GPU Nuclear, Inc.
Route 411 South
Post Office Box 480
Middletown, PA 17057-0480
Tel 717-574-7021

September 30, 1998

Subject: Three Mile Island Nuclear Station, Unit 1 (TMI-1)
Operating License No. DPR-50
Docket No. 50-289
Generic Letter (GL) 96-06, Response to Request for Additional
Information

Attached is the GPU Nuclear response to the NRC's July 13, 1998 request for additional information regarding Generic Letter (GL) 96-06, "Assurance of Equipment Operability and Containment Integrity During Design Basis Accident Conditions."

Figure 1

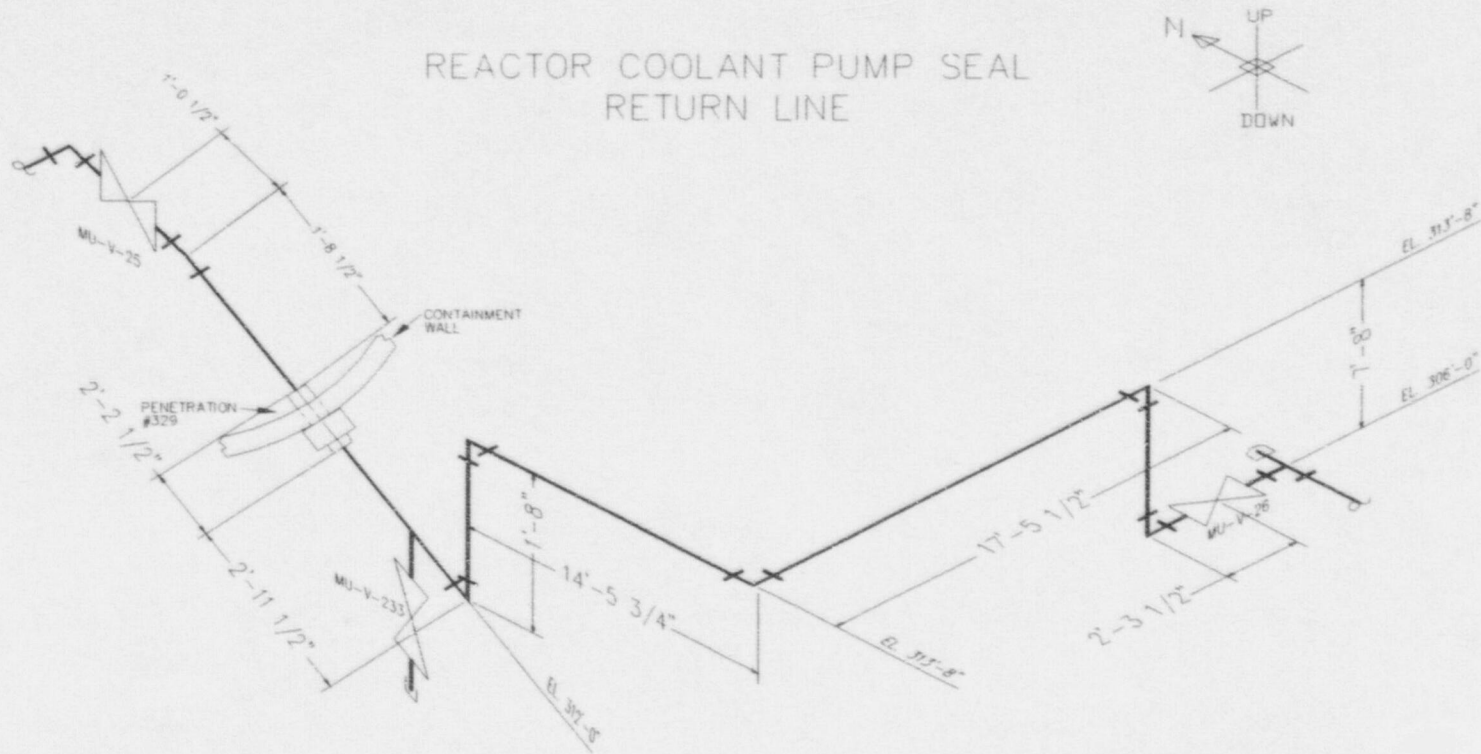
Provide a drawing of the piping run between the isolation valves. Include the lengths and thickness of the piping segments and the type and thickness of the insulation.

See Figure 1

Figure 2

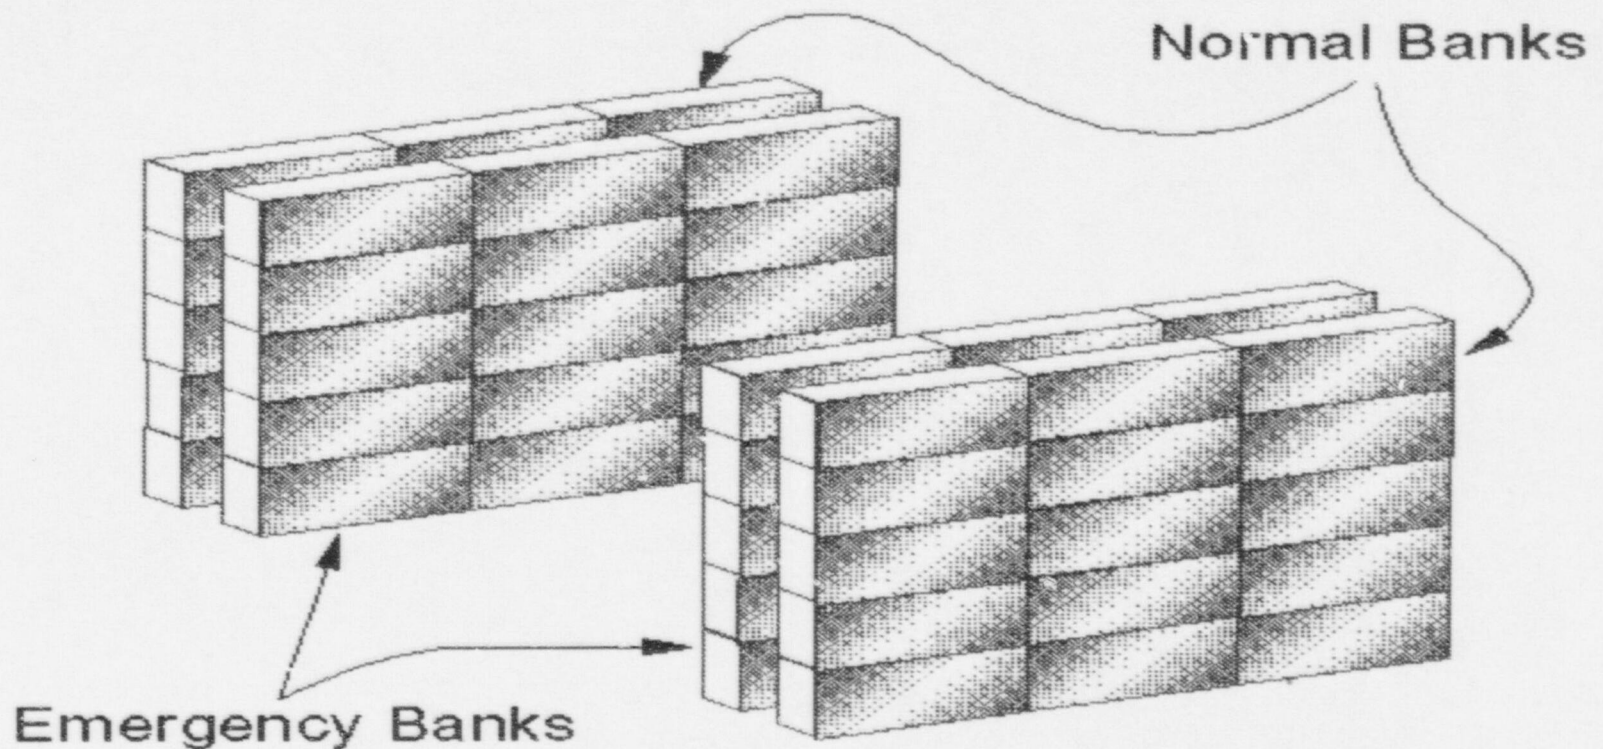
Provide a detailed description of the "worst case" scenarios for waterhammer and two-phase flow, taking into consideration the complete range of event possibilities, system configurations, and parameters. For example, all temperatures, pressures, flow rates, load combinations, and potential component failures should be considered. Additional two-phase flow considerations include:

The GOTHIC computer code (version 5.0e) is used to provide the modeling of the cooling coil and its response to elevated containment temperatures prior to RR pump flow. The approach taken is to use the qualified fan cooler model provided in the computer code and link it with a network of volumes and heat structures designed to represent the cooling water side of the fan coolers. The link is provided using GOTHIC control variables in a feedback loop. Specifically, the portion of the volume heat structure network which represents the cooling coil portion of the river water system is used to drive the fan cooler tube side inlet temperature and convective heat transfer coefficients. From these inputs the fan cooler model calculated the heat transfer rate to the cooling fluid. The calculated heat transfer value is then fed back to the heat structure that represents the cooling coils and heats the fluid in the coil volume. See Figure 2.

For the GOTHIC model the cooling coils were modeled as a set of five control volumes with a set of corresponding heat structures. The use of five control volumes is a natural division for the modeling since the actual fan cooler is divided into five elevations as is illustrated in the figure below.

As can be seen from this figure the cooler banks are divided into a number of smaller cooling coil units (five high by three wide). For each of the control volumes 6 of these smaller cooling units will define a single control volume within the GOTHIC model.

Figure 3

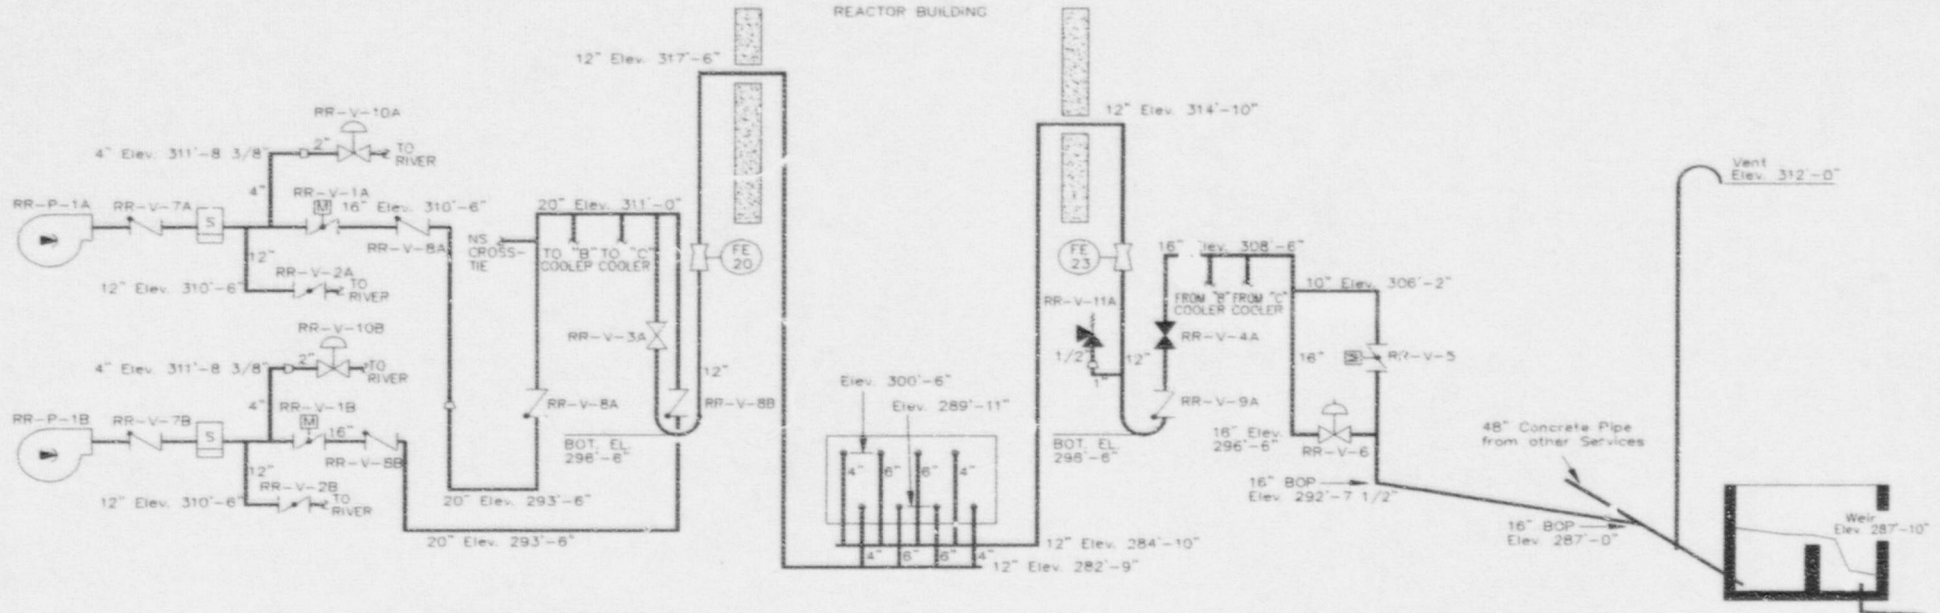
Provide a simplified diagram of the system, showing major components, active components, relative elevations, lengths of piping runs, and the location of any orifices and flow restrictions.

See Figure 3.
